Concerns raised in public submissions

2 Consideration of issues raised in submissions

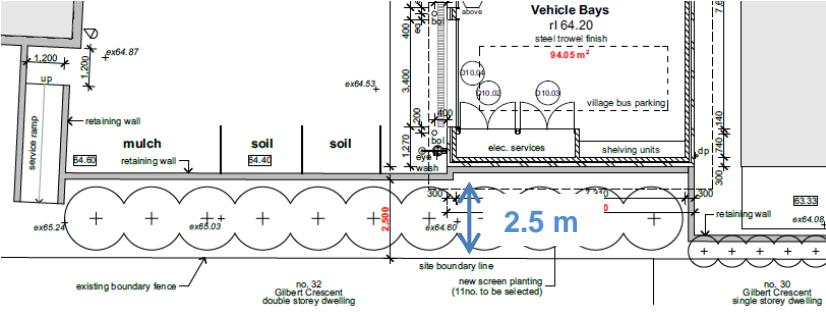
<p>Several objections/complaints have been raised regarding staff and visitors parking on James Cook Drive and accessing the site via the pedestrian gate, which results in limited parking available for nearby residents.</p> <p>The existing emergency vehicular access via James Cook Drive should be converted to general access to reduce the number of staff and visitors parking on James Cook Drive.</p>	<p>Adventist Aged Care has advised that, for the past 8 years, all staff are instructed not to park on James Cook Drive, and this is reinforced in staff newsletters and notices. Visitors are also encouraged to use the on-site car parking, and the Applicant proposes to provide 20 on-site car parking spaces in excess of that required by the Seniors Housing SEPP, to accommodate the parking demand generated by visitors, which is usually for an average time of up to 30 minutes.</p> <p>We are sceptical that the average waiting time is only up to 30 minutes. However, we note that the Applicant is providing an additional 20 car parking spaces above that required by the Seniors Housing SEPP and is continuing to encourage visitors and staff to park on-site in an effort to reduce potential impacts on the surrounding residents.</p> <p>We also note that public parking along the northern side of James Cook Drive is permitted.</p> <p>The Applicant's provision of surplus of car parking, and continued measures to deter staff, residents and visitors from parking on nearby streets are considered to be appropriate measures in response.</p> <p>Given the road access to the site via Elsom Street is an existing arrangement, the conversion of the emergency vehicular access via James Cook Drive to general access is not considered necessary or appropriate from a traffic impact perspective.</p>

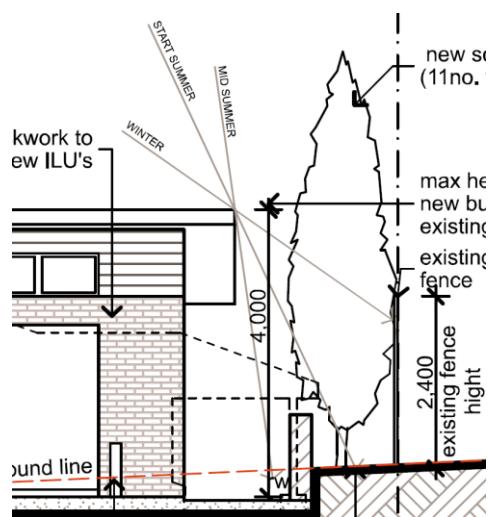
<p>Concern has been raised regarding adverse impacts of the proposed maintenance shed on the adjoining residential property to the south with regard to:</p>	
<p>i. Height (substantially higher than the adjoining new ILU)</p>	<p>The proposed shed will have a height of approximately 4 m. Compared to the existing boundary fencing which has a height of 2.4 m, the shed's skillion roof will be 0.5 m to 1.2 m above the height of the fence. The ground level of the shed is approximately 700 mm lower than the existing ground level (bottom of the fence) at the boundary.</p>

<p>The Applicant has demonstrated that the overall height of the shed is similar to the existing ILU building to the west and the proposed ILU building to the east, as shown on the Maintenance Facility Elevations Sheet 1, Drawing No. DA30 provided at Attachment 5. An extract of the section which demonstrates the height of the shed and neighbouring ILUs is as follows (the portion of the shed above the existing boundary fencing which is to be retained is highlighted in yellow):</p>  <p>The height of the proposed shed is considered to appropriate relative to the existing and proposed height of the neighbouring ILUs, and is appropriate given it complies with the building height permitted on this site.</p> <p>ii. The levels of the foundation of the shed should be reduced to match the level of the new ILU Unit 7</p> <p>The Applicant has demonstrated that the proposed floor level of the shed is appropriate given the gradual fall across the site and the height relative to the adjoining property to the south.</p> <p>An extract of the Maintenance Facility Elevations Sheet 1, Drawing No. DA30 is provided below which demonstrates that the ground level of the shed is approximately 700 mm lower than the existing ground level (bottom of the fence) at the boundary.</p>  <p>The Applicant has considered lowering the level of the shed to match the ILU to the east (Unit 7), however advises that inappropriate levels would result to enable vehicular access from the internal driveway to the service yard and vehicle bays within the shed.</p> <p>The proposed levels reflect the stepping down of the existing and proposed ILUs and the shed relative to the slope of the site, and is considered appropriate.</p>
